RENESAS TECHNICAL UPDATE

Product Category	MPU/MCU		Document No.	TN-SH7-A717A/E	Rev.	1.00
Title	About R4S76191(SH7619 2ndCut)		Information Category	Product Generation Change		
Applicable Product	All series of SH7619 [R4S7619(0/1)(B/N/D/W)125BG(V)]	Lot No.	Reference Document	SH7619 Group Hardware Manual Rev5.0 (REJ09B0237-0500)		
		All lots

Fig. Mark specification of 2ndCut.

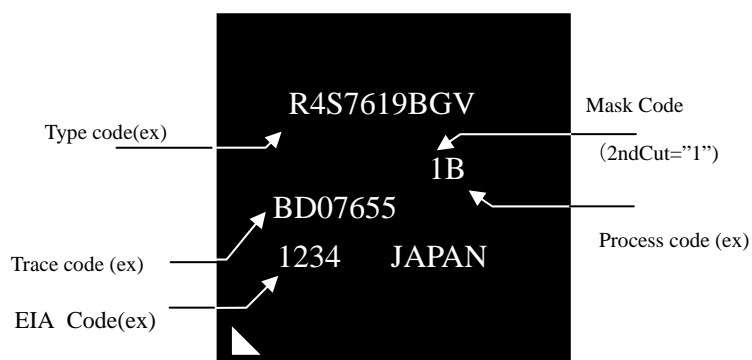
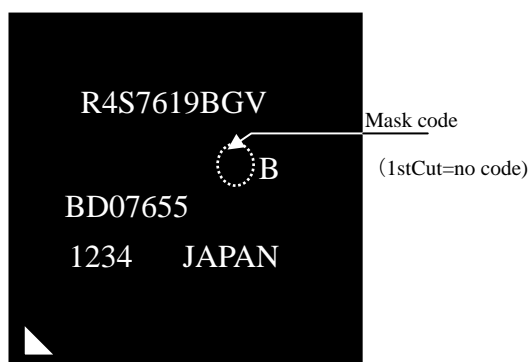
You could identify its type codes and marks of the package.

2ndCut	1stCut
Type code	R4S76191*****	R4S76190*****
Mark character	Mask Code=1	No mask code
function	Removing the limitation of a technical update (TN-SH7-A574A/E)	-
Package outline	Same as 1stCut	-
